45 New Keys, woven into the existing Mountain Casitas & Suites, at the Sanctuary Spa and Resort on Camelback Mountain in Paradise Valley

RESPONSES TO ACCOMPANY 12 APRIL SUBMITTAL

The Views

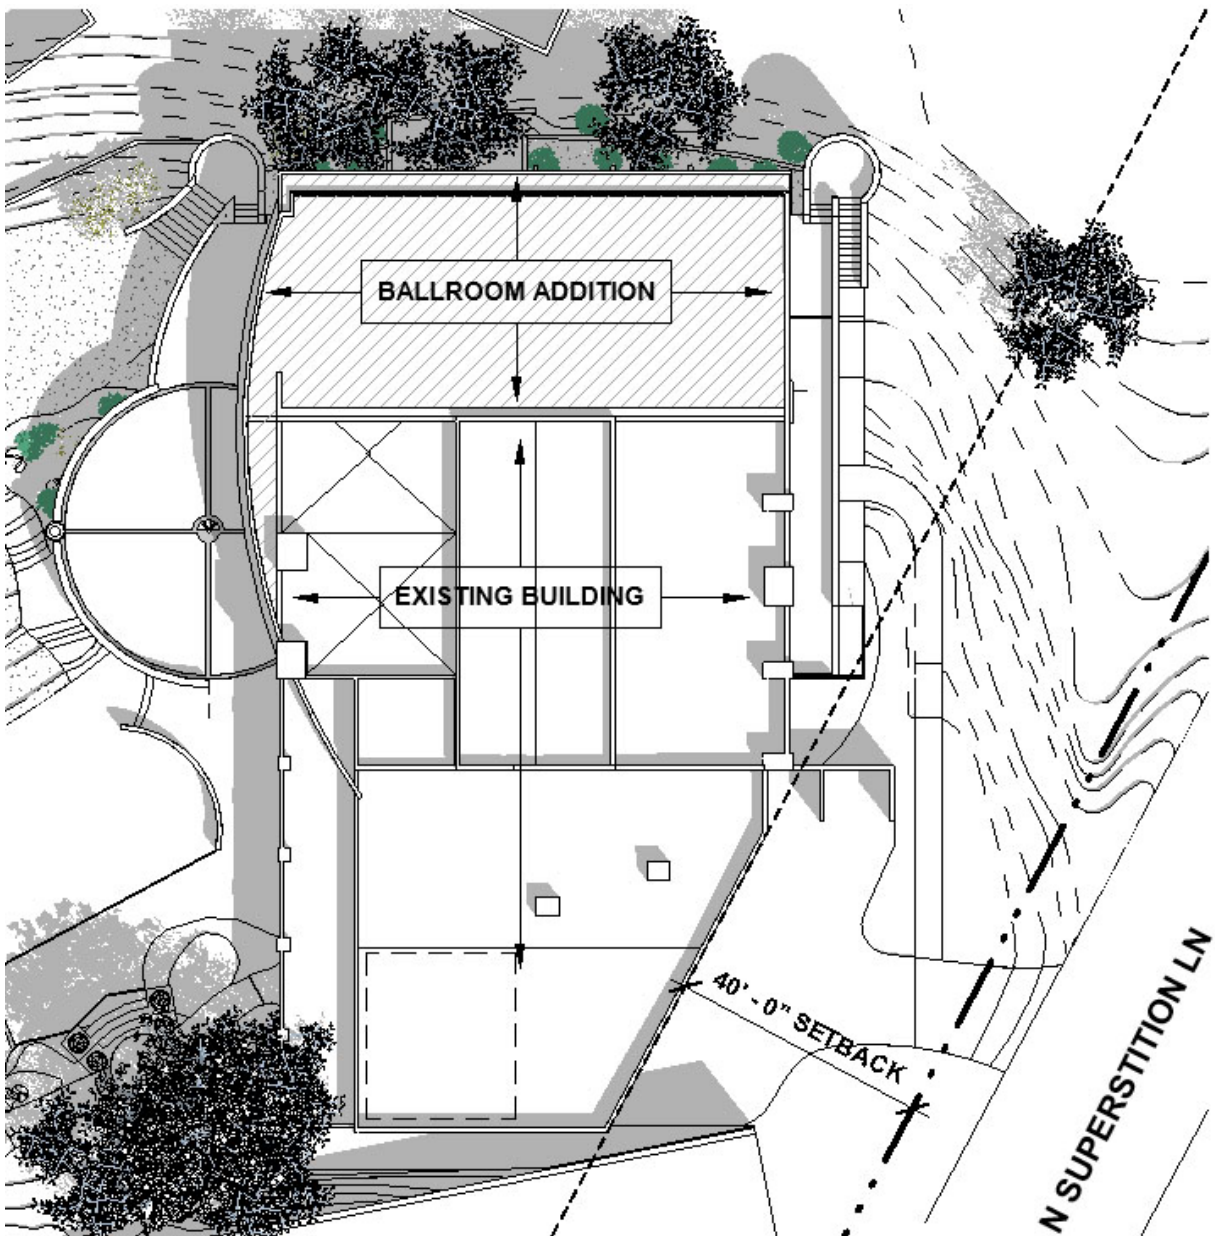
- 1.0)** The parcel on which the Views Conference Center expansion is proposed there is an existing minimum setback of 40', to which the new expansion adheres.

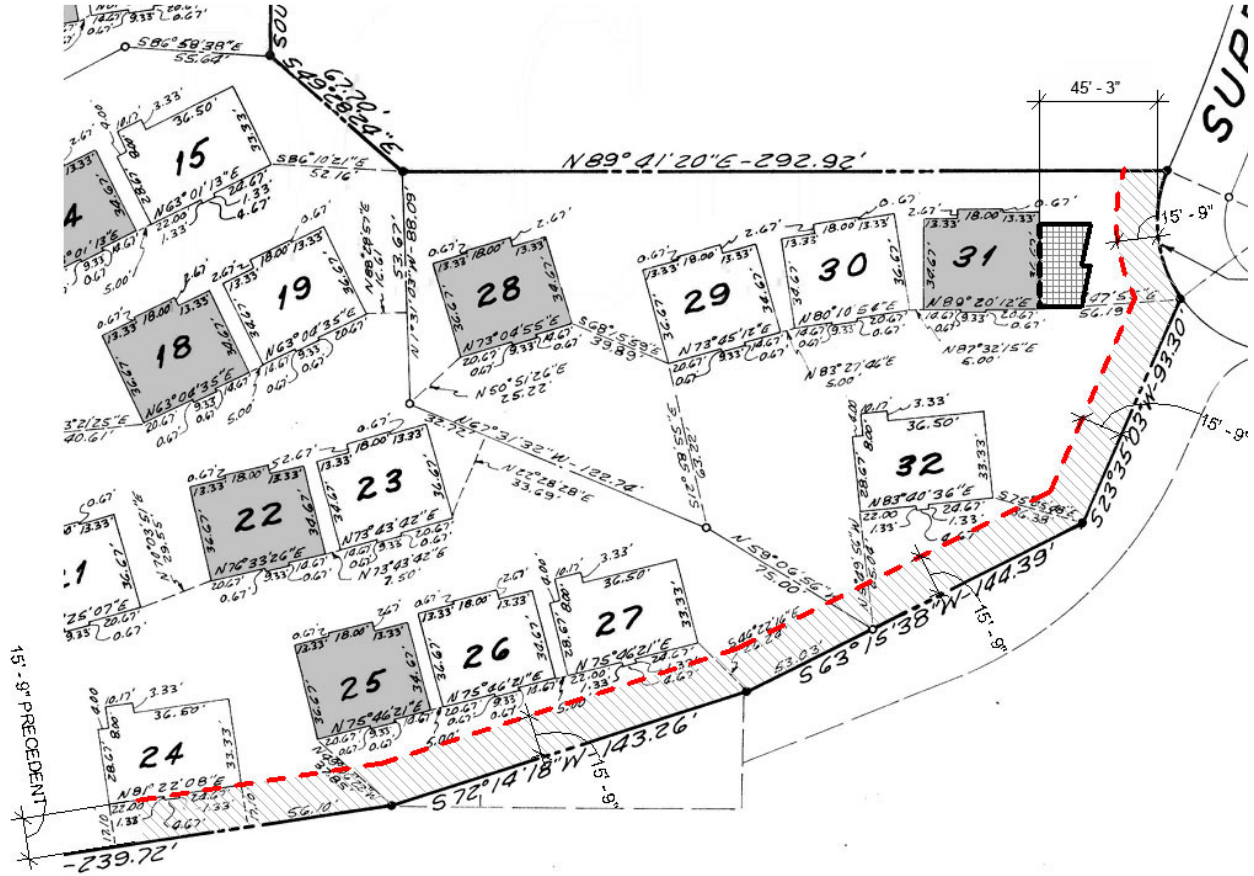
2.1) The existing parcel spacing precedent condition in the current SUP along a roadway is 15'-9" (established at hillside casita parcel 24 (172-02-068)). All proposed hillside casita improvements (as shown in hatched area) along Superstition Lane exceed the parcel spacing precedent condition.

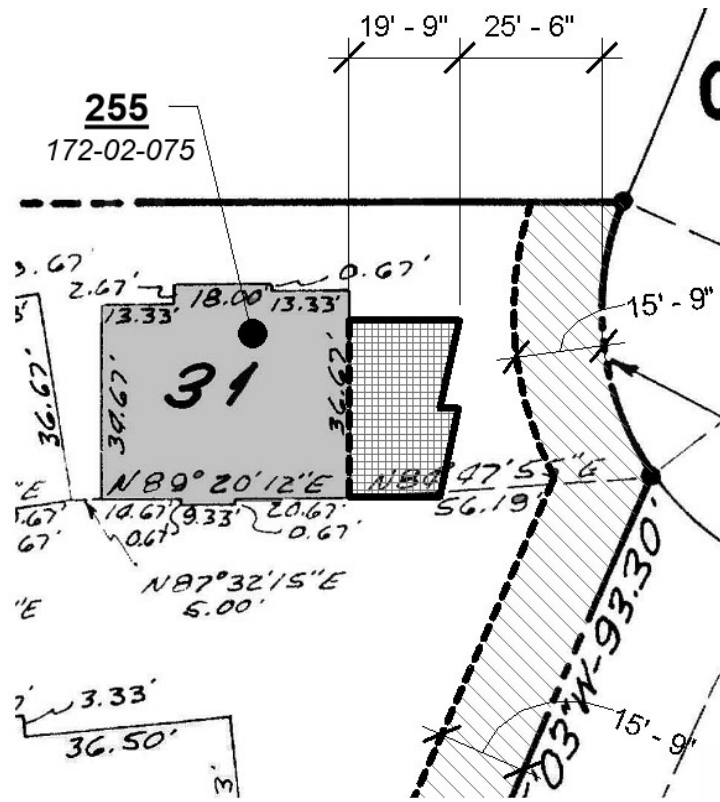
2.2) Hillside casita parcel 31 (172-02-075; Sanctuary Casita 255), lies well within the precedent condition under the current SUP. The proposed improvements are on the east side of the parcel. Currently there exists 45'-3" parcel spacing between the east property line and the Superstition Lane ROW. When the legal description of the parcel is amended to modify the footprint, there would remain a distance more than 25' between new property line and ROW, exceeding the 15'-9" of existing parcel spacing precedent.

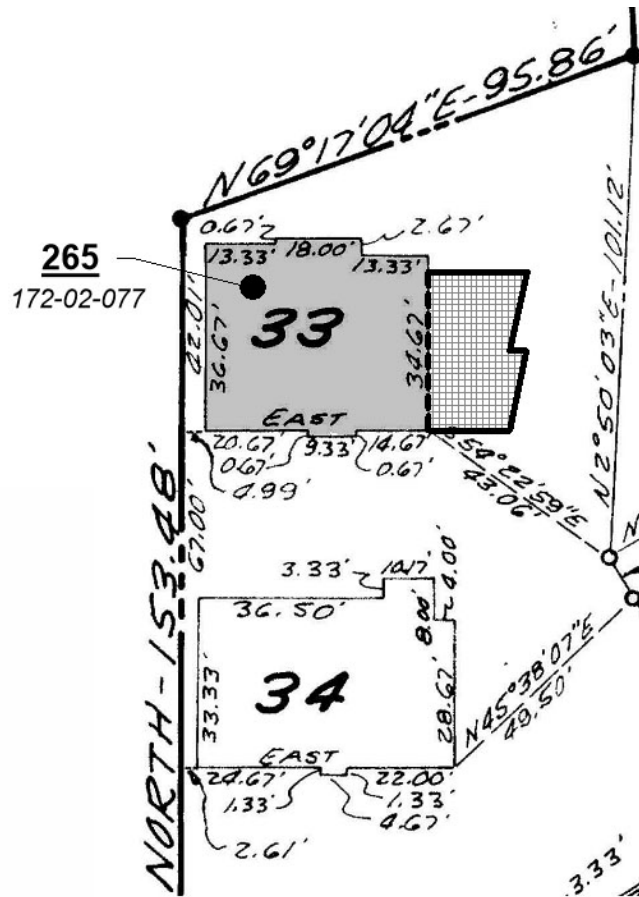
2.3) Following the precedent condition of the existing hillside casita parcels adjacent to a property line shared with another Sanctuary property line, the parcel spacing precedent established is 2.61'. [see below: parcel 34 (172-02-078) and the property line of the Sanctuary Gallery House (172-02-088)]. The proposed keys in this case, shown as the hatched area, are within the current SUP parcel spacing precedents.
